FINAL DRAINAGE REPORT

TRAILS AT ASPEN RIDGE Filing No. 3

April 2021

SF-21-002

StormCAD Layout-Trails at Aspen Ridge Filing No. 3 updates

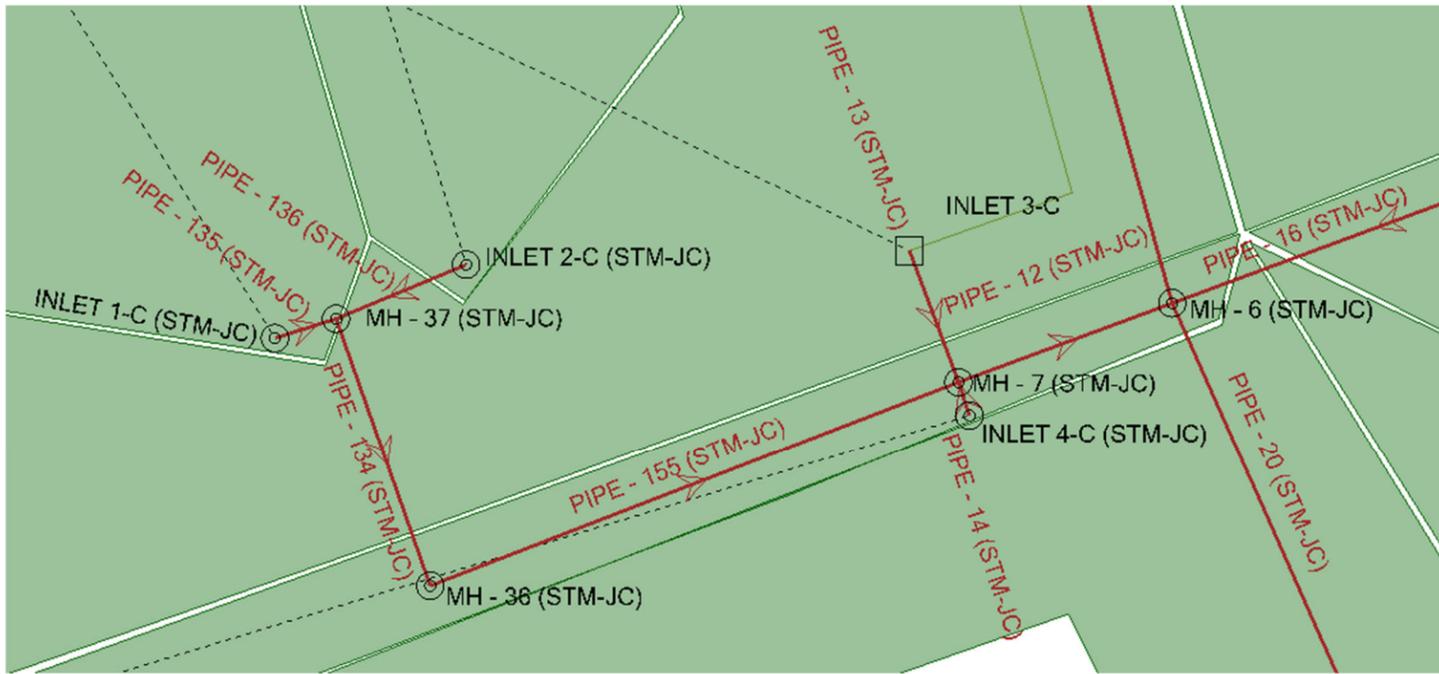
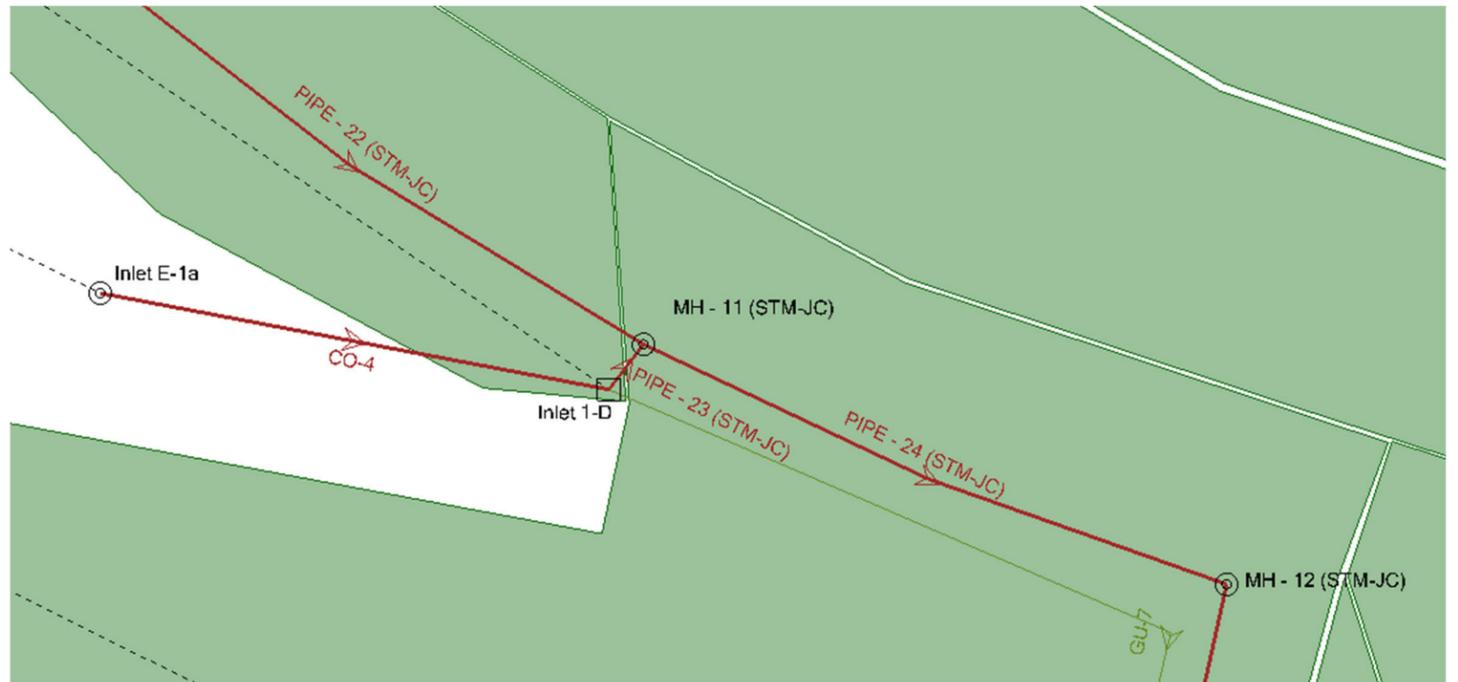
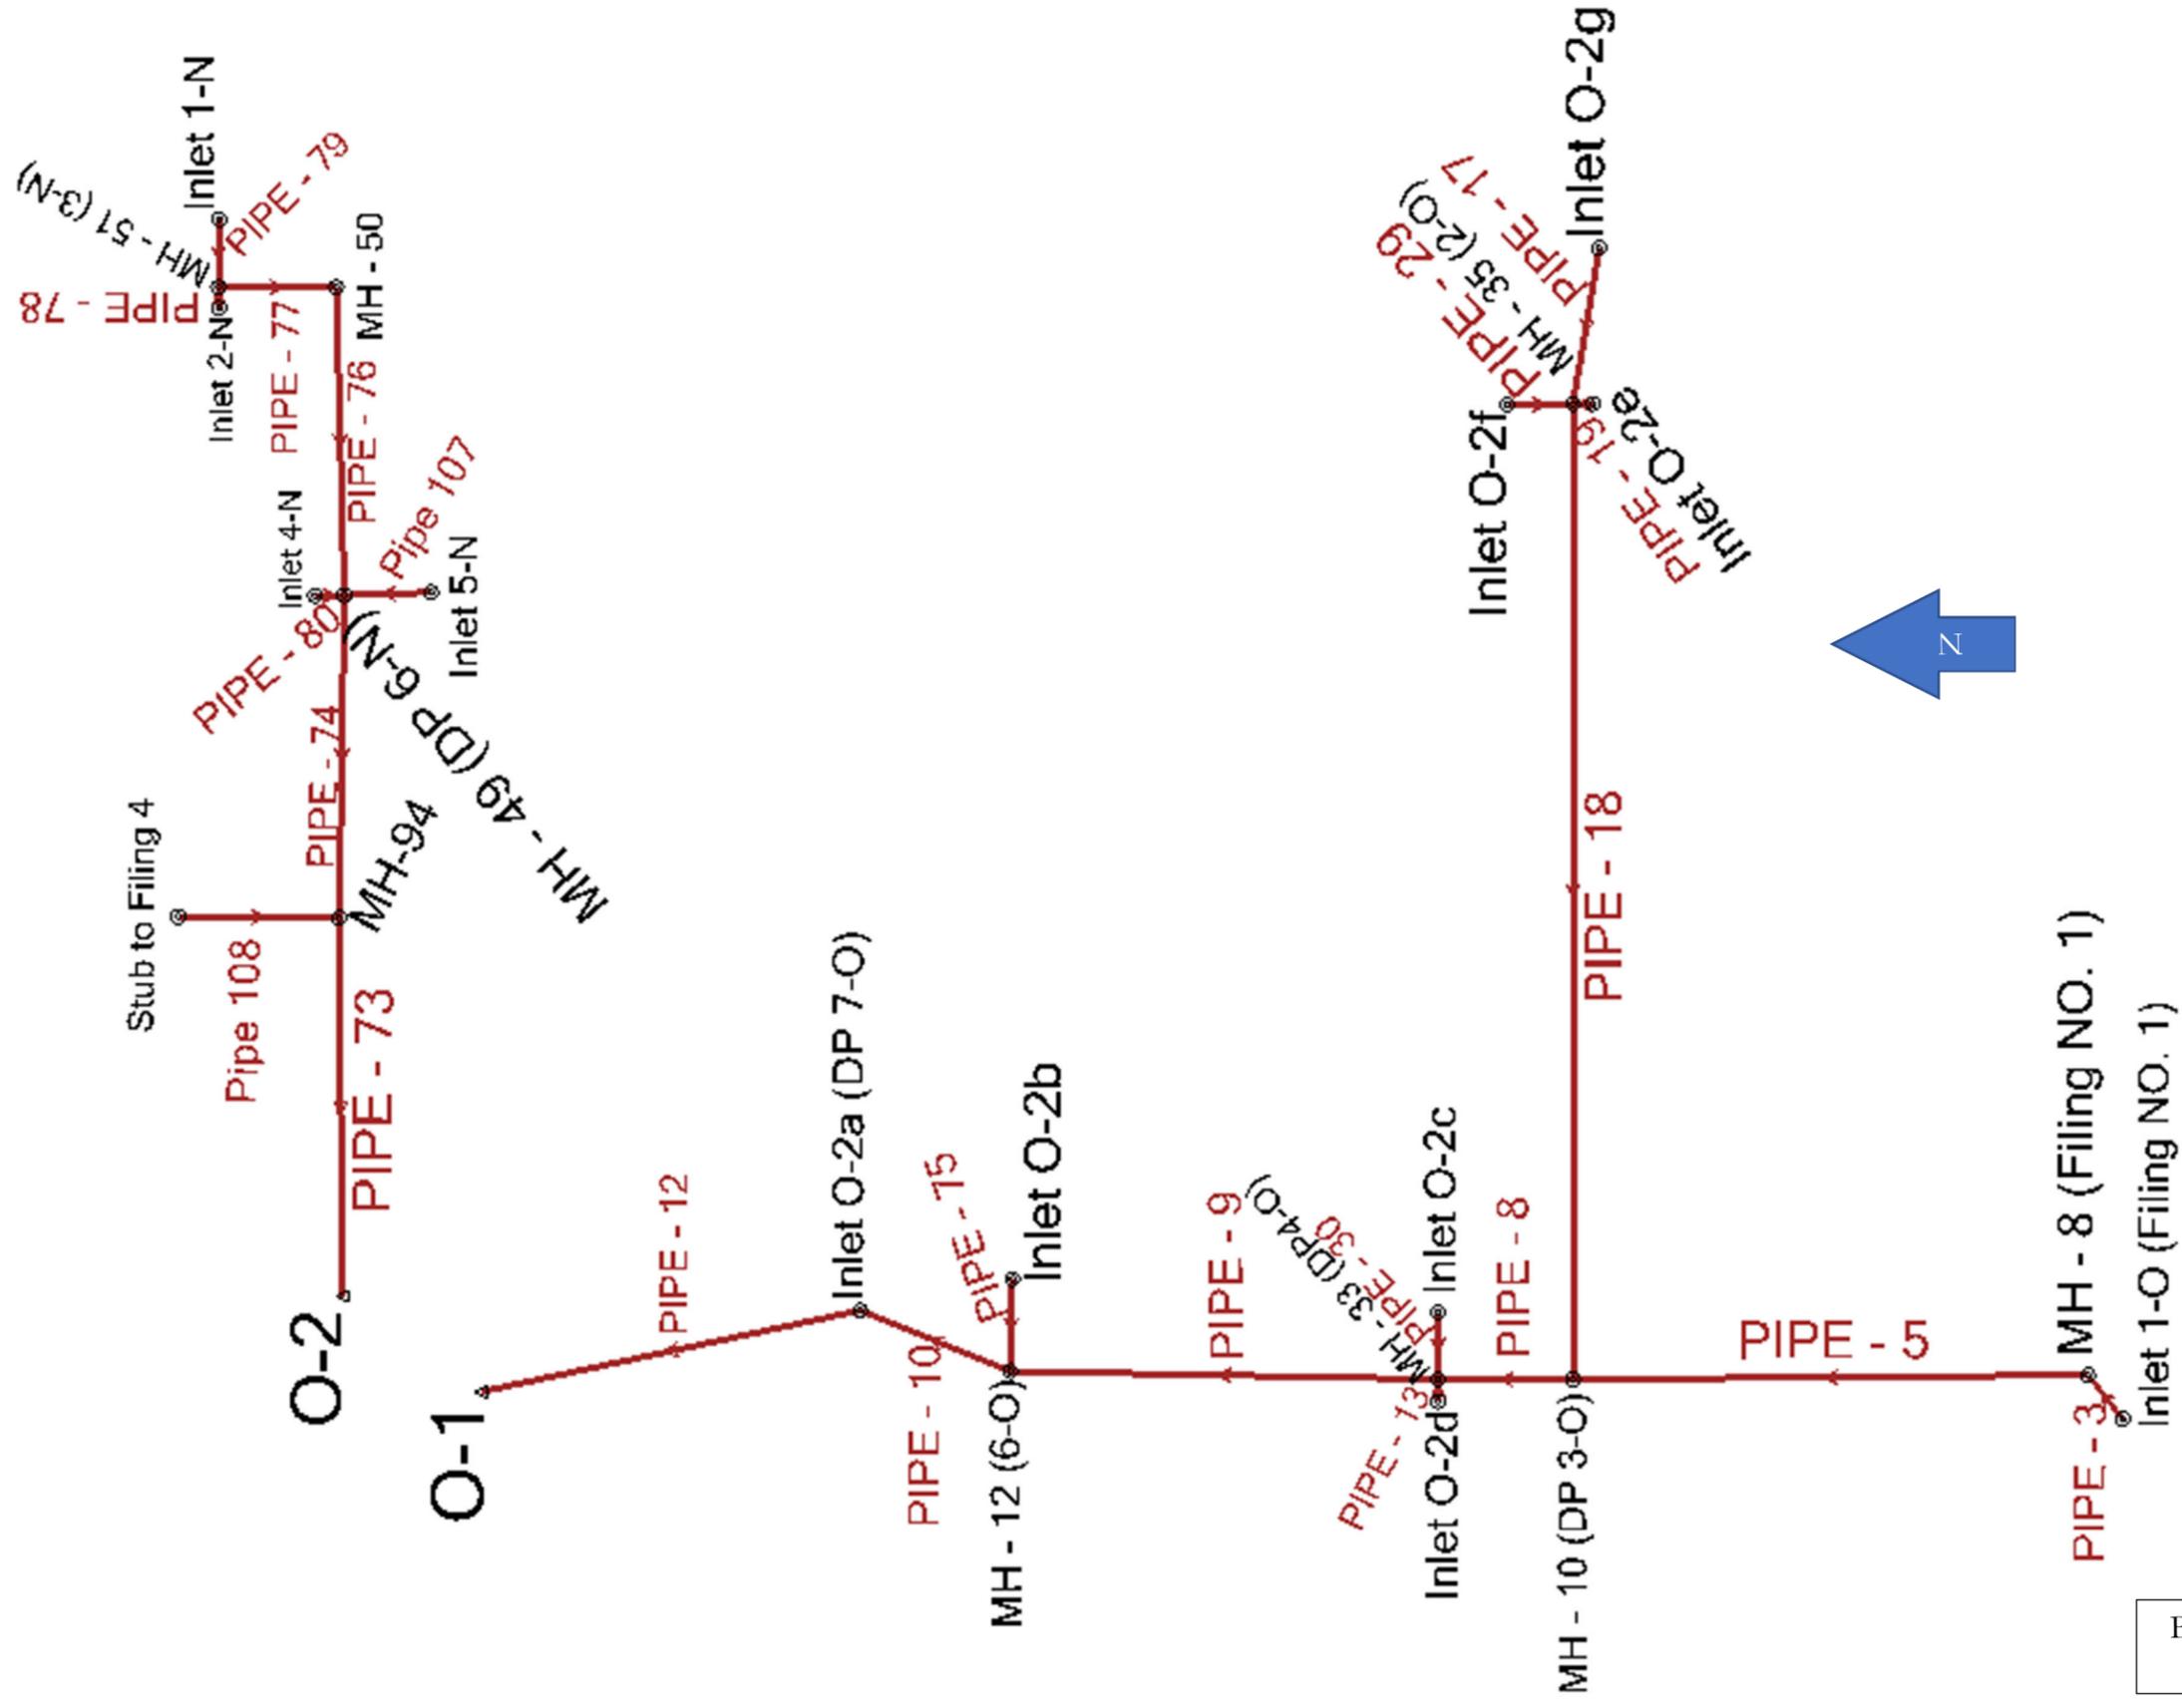
Staff requests revising the schematic exhibit to a larger sheet that shows the entire system. It's difficult to determine where the viewports are located on the overall development.

Since this is StormCAD overlay the schematic on top of the subdivision layout. It's difficult to identify where some of these sections are located.

DESIGNED BY: JTS	SCALE:	DATE ISSUED: MARCH 2021	DR-01
DRAWN BY: JTS	HORIZ:	SHEET NO. 1 OF 3 SHEETS	
CHECKED BY:	VERT:

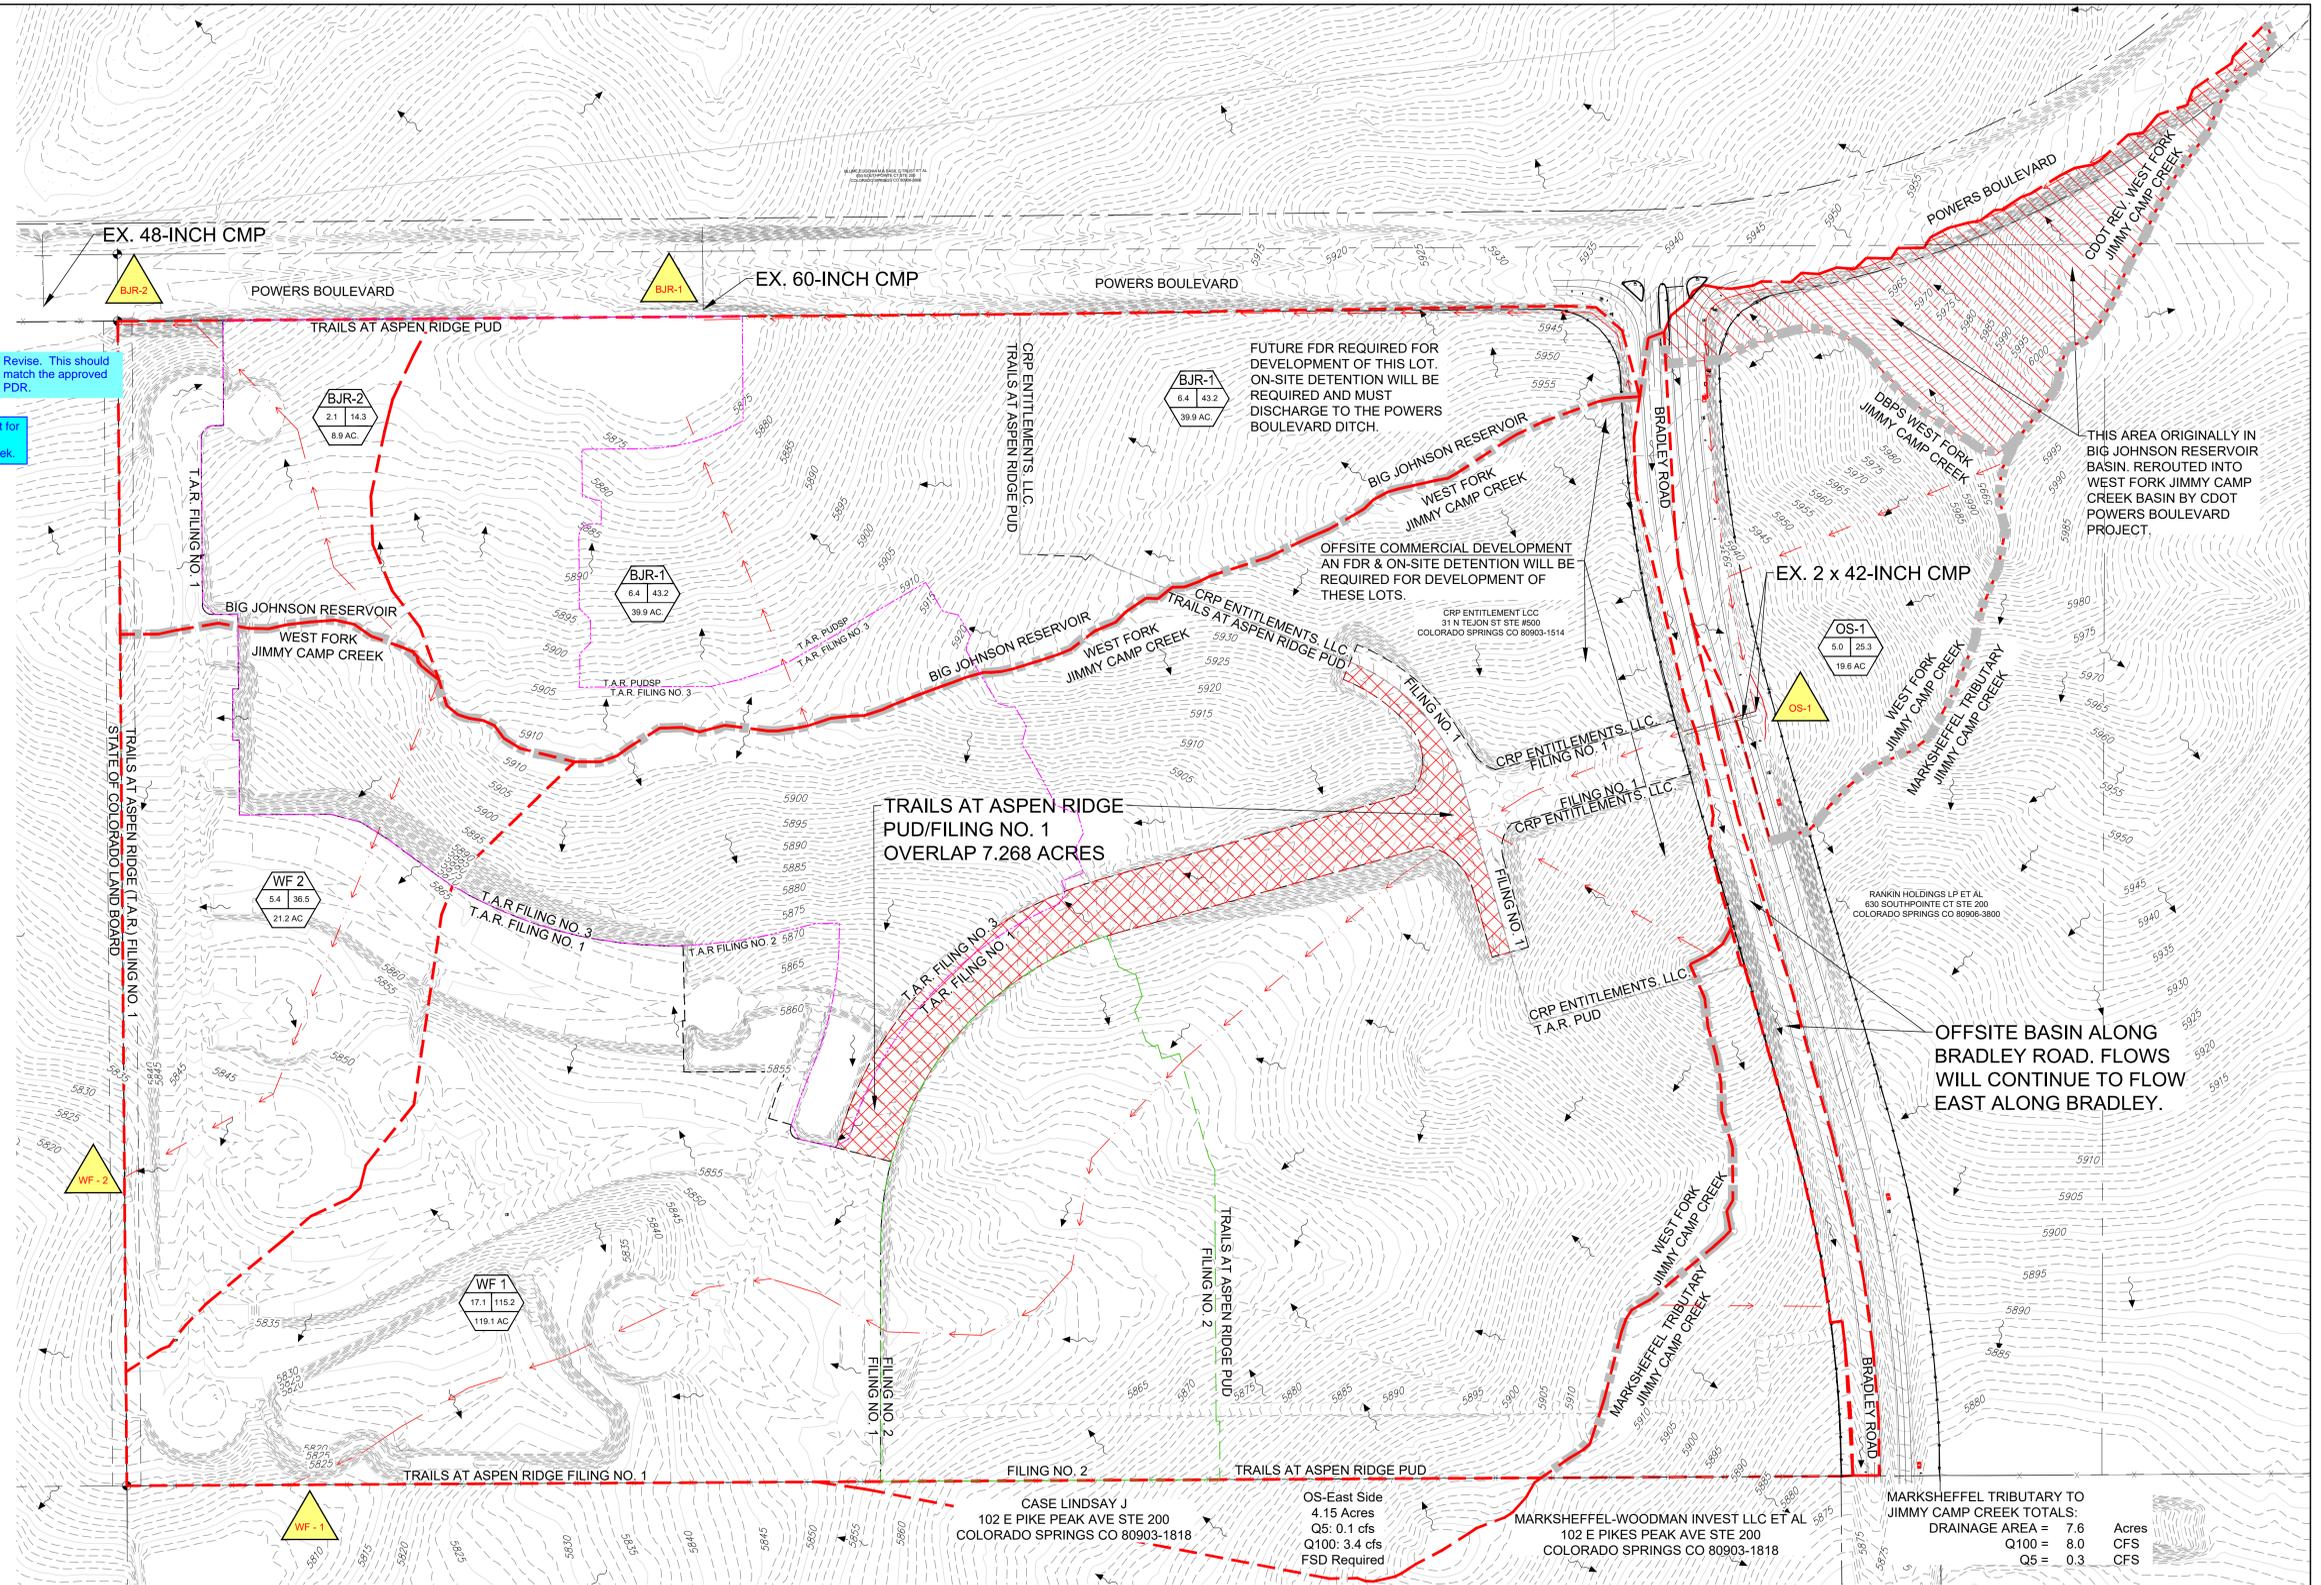
Revise. This should match the approved PDR.

Revise to account for offsite runoff of Jimmy Camp Creek.

Provide a more detailed title like "Existing (or Pre-Development) Drainage Conditions"
